NEDO-33005-A
Revision 1
February 2017

Licensing Topical Report

TRACG Application for Emergency Core Cooling Systems / Loss-of-Coolant-Accident Analyses for BWR/2-6

SUBJECT: FINAL SAFETY EVALUATION FOR GE HITACHI NUCLEAR ENERGY - AMERICAS, LLC TOPICAL REPORT NEDE-33005P AND NEDO-33005, REVISION 0, "LICENSING TOPICAL REPORT TRACG APPLICATION FOR EMERGENCY CORE COOLING SYSTEMS / LOSS-OF-COOLANT-ACCIDENT ANALYSES FOR BWR/2-6" (CAC NO. ME5405)

Figure 6.2-1 Typical MELLLA+ Power/Flow Map

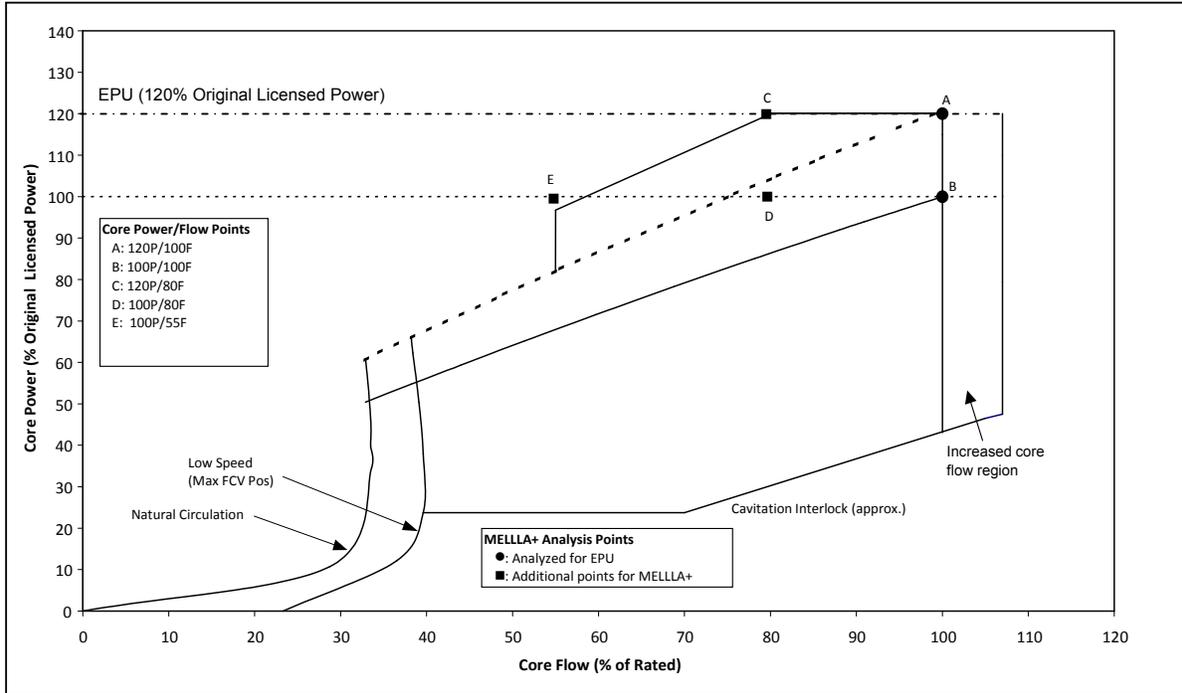
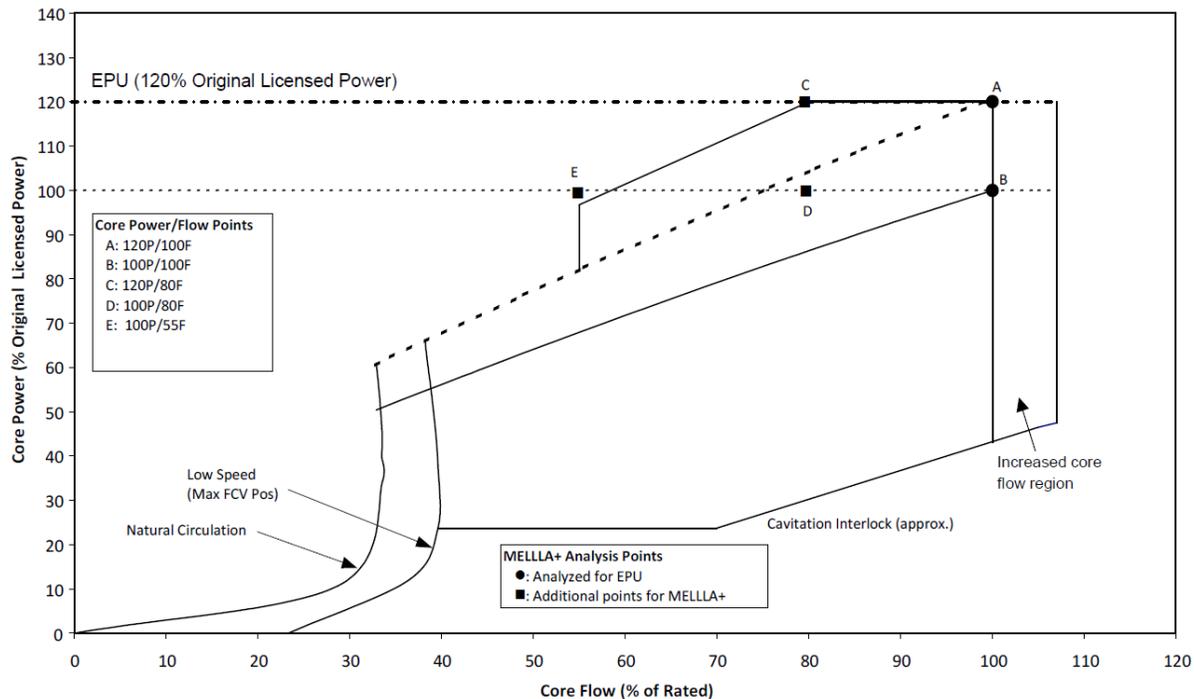
<p>Section 5.2 Operating Statepoints</p>	<p>Page 21: The figure should be cited from the MELLLA+ LTR and referred to as typical since some plant-specific maps are different.</p> <p>GEH suggests the following change (Line 5): <u>A typical</u> The MELLLA+ operating domain is illustrated <u>in Figure 1-1 of Reference 58</u> Figure 2.</p> <p><i>Suggested change shown in the markup.</i></p>	<p>The figure in question is a reproduction of Figure 6.2-1 of NEDE-33005P. Since the figure was obtained from the LTR that is the subject of the SE, the NRC staff retained the figure as-is.</p> <p>The proposed change is modified as follows: A typical The MELLLA+ operating domain is illustrated in Figure 2, which is a reproduction of Figure 6.2-1 of NEDE-33005P.</p>

Location	GE Comment	NRC Disposition
Section 5.2 Operating Statepoints	<p>Page 21: The figure should be cited from the MELLLA+ LTR and referred to as typical since some plant-specific maps are different. If the figure is retained, then a better figure is needed since the figure in the SE has Points D and E misaligned.</p> <p>GEH suggests the following change (Line 7): Replace Figure 2 with Figure 1-1 from Reference 58.</p>	<p>The figure in question is a reproduction of Figure 6.2-1 of NEDE-33005P. Since the figure was obtained from the LTR that is the subject of the SE, the NRC staff retained the figure as-is. Change not accepted.</p>
Section 5.2 Operating Statepoints	<p>Page 21: If Figure 1-1 from Reference 58 replaces the existing Figure 2, then the points analyzed for MELLLA+ plants needs to be revised.</p> <p>GEH suggests the following change (Line 11): points <u>A</u>, <u>B</u>, <u>D</u>, and <u>E</u> in Figure 2. <i>Suggested change shown in the markup.</i></p> <p>Note that if the existing Figure 2 is not replaced, then the points should be A, C, and E.</p>	<p>The figure contained in NEDE-33005P was retained in the SE (i.e., existing Figure 2 was not replaced); therefore, the GEH suggestion to identify Points A, C, and E was considered by the staff. As noted on Page 71 of the SE, the applicable requirement for MELLLA+ is to analyze, “the rated EPU [extended power uprate] power/rated CF [core flow], rated EPU power/minimum CF, and the low-flow MELLLA+ boundary (Transition Statepoint). These correspond to Points A, C, and E, on the figure. Therefore, the NRC staff agrees with this suggested change because it is consistent with the MELLLA+ analytic requirements. The proposed change is modified as follows: points A, C, and E in Figure 2.</p>

A typical MELLLA+ operating domain is illustrated in Figure 2, which is a reproduction of Figure 6.2-1 of NEDE-33005P.

Figure 8.1-29 Summary of BWR/4 Statistical Analyses at Various Break Sizes

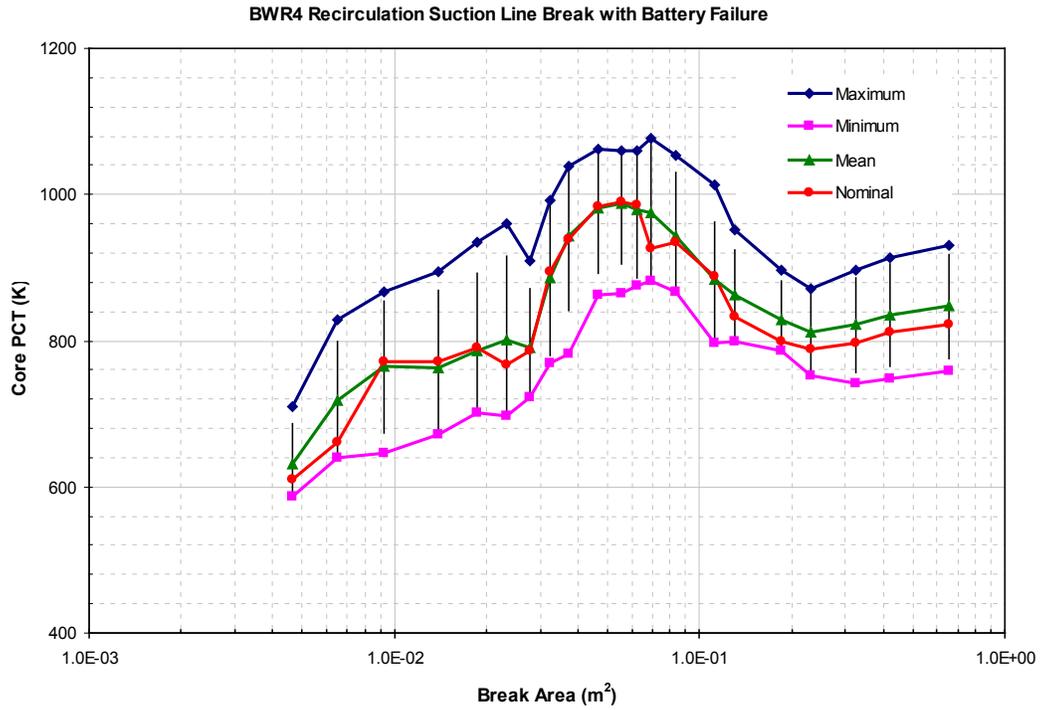
revising the jet pump plant nodalization studies documented in LTR Section 5.2, Table 5.2-1 and Figures 5.2-1 through 5.3-9 and the key summary demonstration analyses documented in LTR Chapter 8, Figure 8.1-29 for the BWR/4 and Figure 8.2-18 for the BWR/6.

Location	GE Comment	NRC Disposition
	<p>Figure 8.1-29 for the BWR/4 and Figure 8.2-18 for the BWR/6 of the LTR, or by performing analyses of specific plants.</p> <p><i>Suggested change shown in the markup.</i></p>	
<p>Section 11.0 Conclusion</p>	<p>Page 80: GEH suggests the following change (Lines 19-21): For the purpose of compliance with 10 CFR 50.46 requirements, TRACG-LOCA, as documented in Reference 1 <u>and revised by the RAI responses</u>, may be considered an acceptable evaluation model. With regard to referencing in licensing actions, Reference 1 <u>as revised by the RAI responses</u> may be considered approved for use.</p> <p><i>Suggested change shown in the markup.</i></p>	<p>The NRC staff intent in the discussion is consistent with the vendor proposed revision. The NRC finds the change acceptable. Change incorporated in final SE.</p>
<p>Section 12.0 References</p>	<p>Pages 81-82: GEH suggests the following changes:</p> <ul style="list-style-type: none"> • Page 81, Line 43: Reference 17: MFN 07-457452 • Page 82, Line 47: Reference 31: December 20<u>8</u> <p><i>Suggested change shown in the markup.</i></p>	<p>The change is editorial. The NRC finds the change acceptable. Change incorporated in final SE.</p>

Figure 8.3-23 Break Spectrum for BWR/2 Discharge and Suction Side Breaks

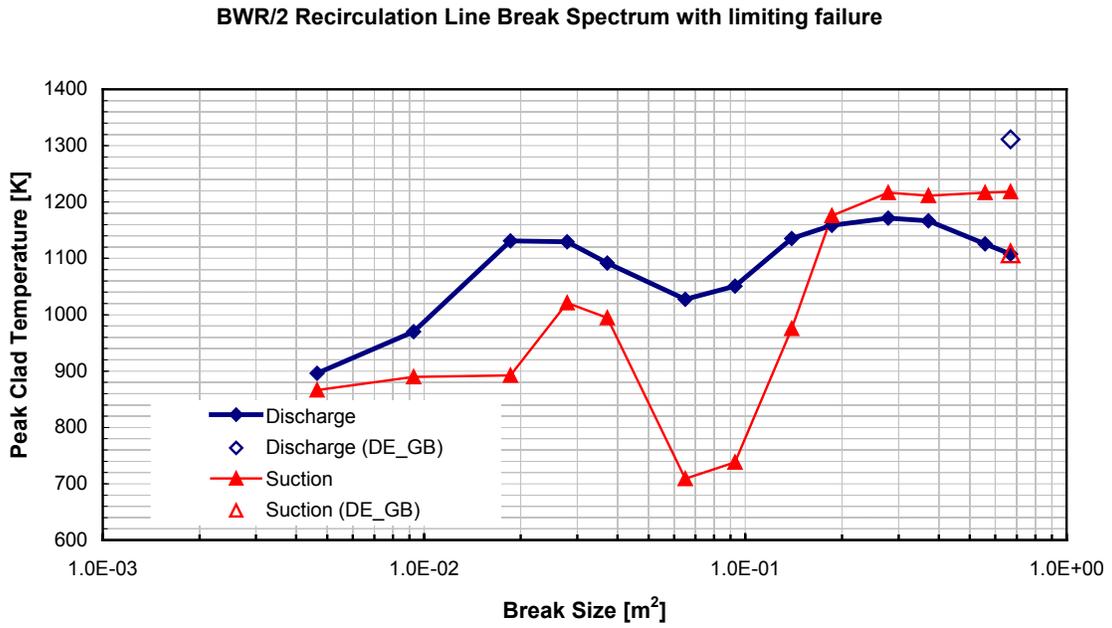
The BWR/2 break spectrum is shown in Figure 8.3-23 of Reference 1. For the BWR/2, the limiting PCTs are produced by the larger breaks. In particular, the limiting PCT is produced by a double-ended guillotine break on the recirculation discharge. The results of the uncertainty analysis for this break are shown in Figures 8.3-33 and 8.3-34. [[

Figure R104-3 Shumway Compared to SS and Inconel Data {Fig. 5 in [R104- 2]}

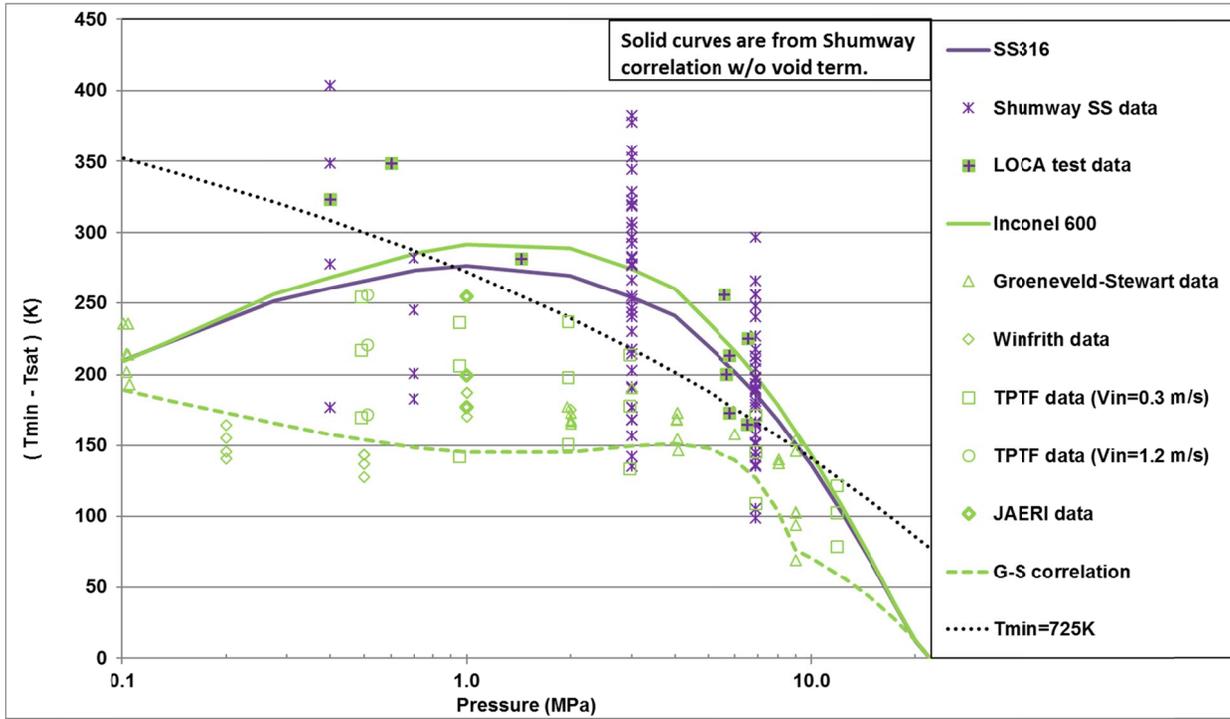
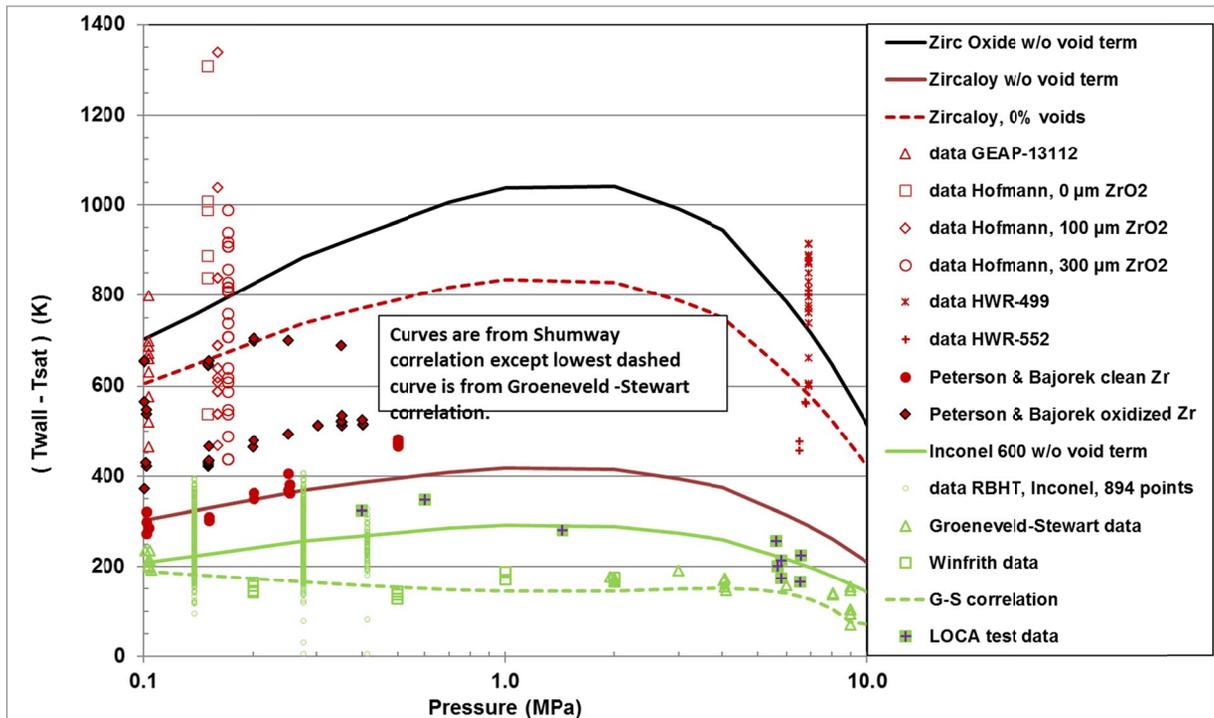
In Reference 41, GEH provides an evaluation of the Shumway correlation, comparing it to other, similar correlations and various sources of quench data. Perhaps most notably, GEH provides a comparison of Shumway for various materials, including zirconium, zirconium oxide, and the Groeneveld-Stewart correlation that is implemented in the NRC's TRACE code. The data sources include fresh and oxidized zircaloy, as well as Inconel 600. From Figure 6 of Reference 41, it can be seen that the Shumway correlation trends well with Peterson and Bajorek data (Reference 43) for unoxidized zircaloy, and that the data for oxidized zircaloy fall significantly above the Shumway correlation prediction for unoxidized zircaloy.

^S This comparison was made by evaluating the data shown in Figure 6 of MFN 13-073, and the data shown in Figure 7 of the Peterson and Bajorek paper. When corrected for units and saturation conditions at the given pressure, it can readily be seen that the Shumway correlation exhibits asymptotic behavior, with the pressure effect leveling off at approximately 1 MPa, just as the data for stainless and carbon steel suggest.
